**RE: Window replacement**  
**7316 Willow Avenue, Takoma Park Historic District #37/003**  
**Historic Preservation review pursuant to County Code Chapter 24A-6**

The above-referenced proposal, originally applied for under HAWP 1150530, has been received and reviewed. The project involves replacement of glazing in the 15-lite picture window on the front elevation of the subject property, per the attached details.

7316 FRONT PICTURE WINDOW

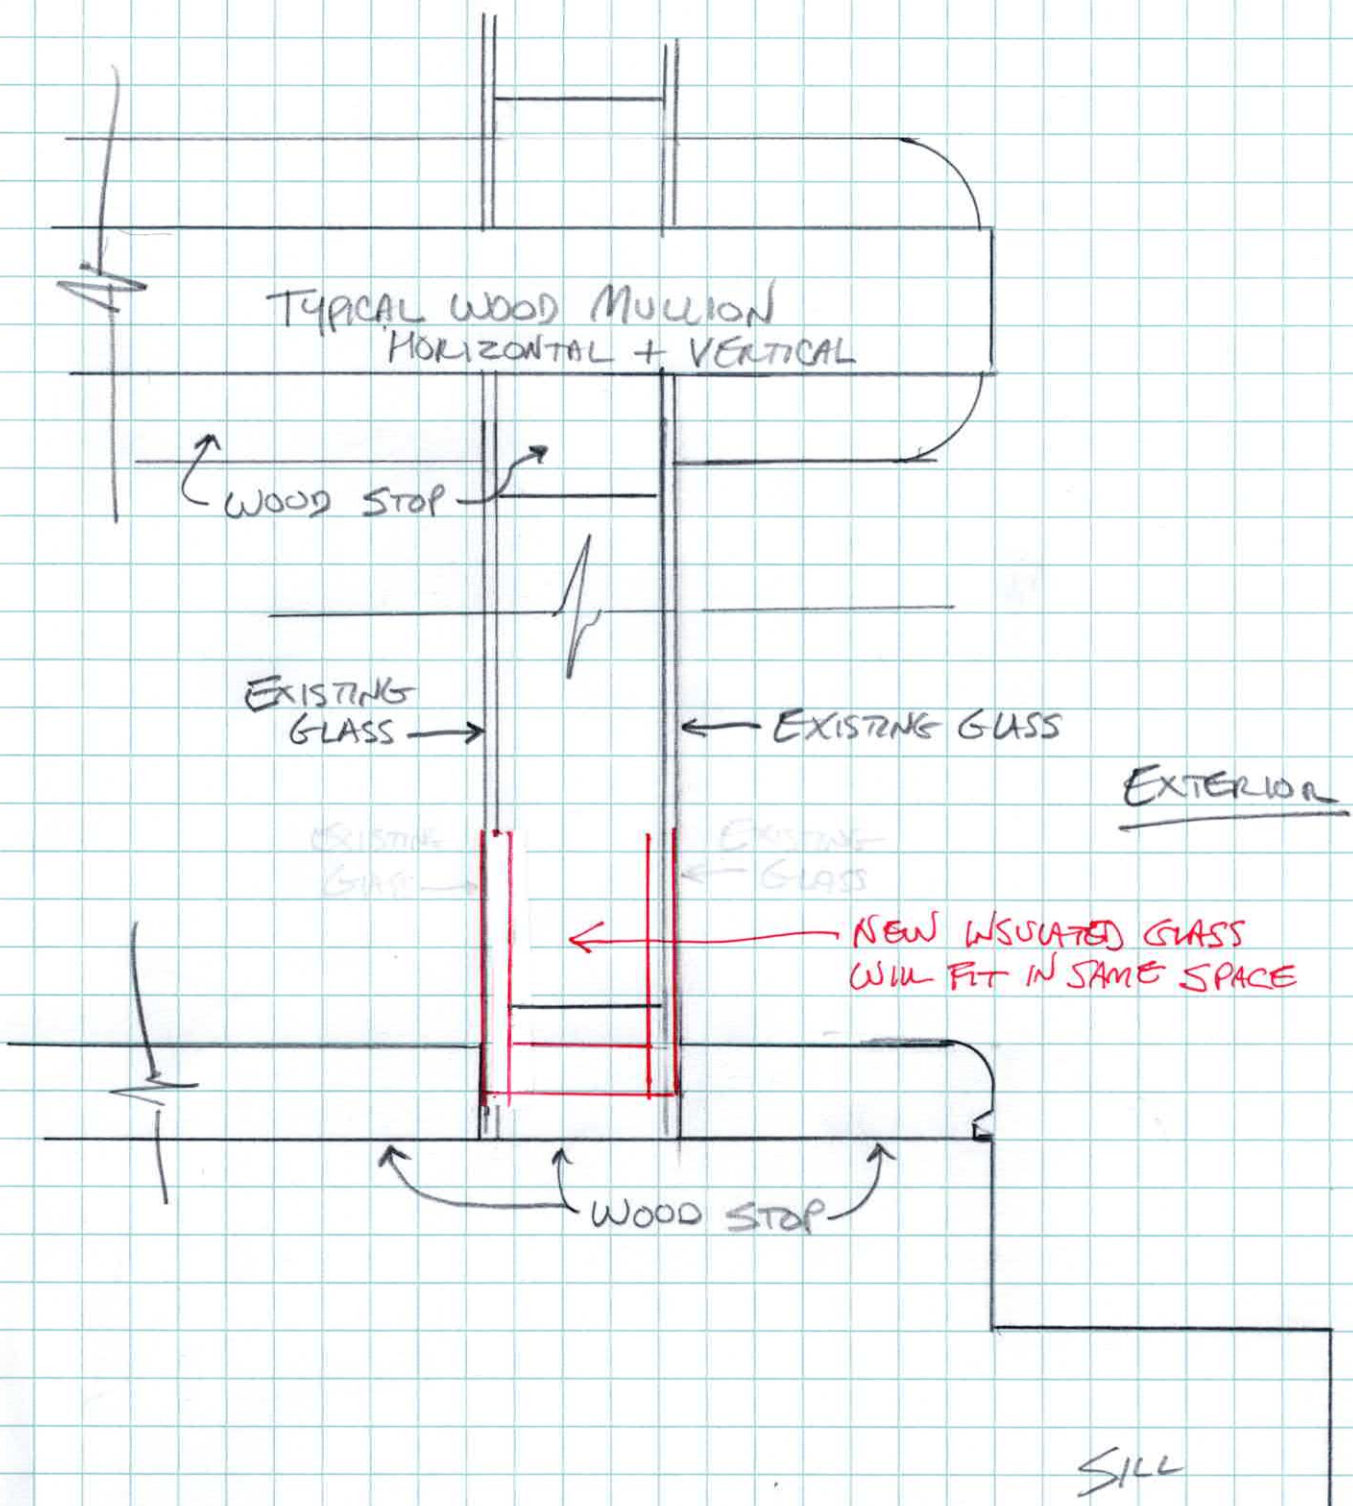
It is my opinion that this project constitutes ordinary maintenance and will have no material effect on the historic resource. Therefore, I find that no further review under the Montgomery County Historic Preservation Ordinance (Chapter 24A) is warranted. Though a HAWP was applied for, the permit is not required, unless changes are made to the current plans. We will request that the Department of Permitting Services purge the above-referenced HAWP application. Please secure all necessary building permits from the Department of Permitting Services.
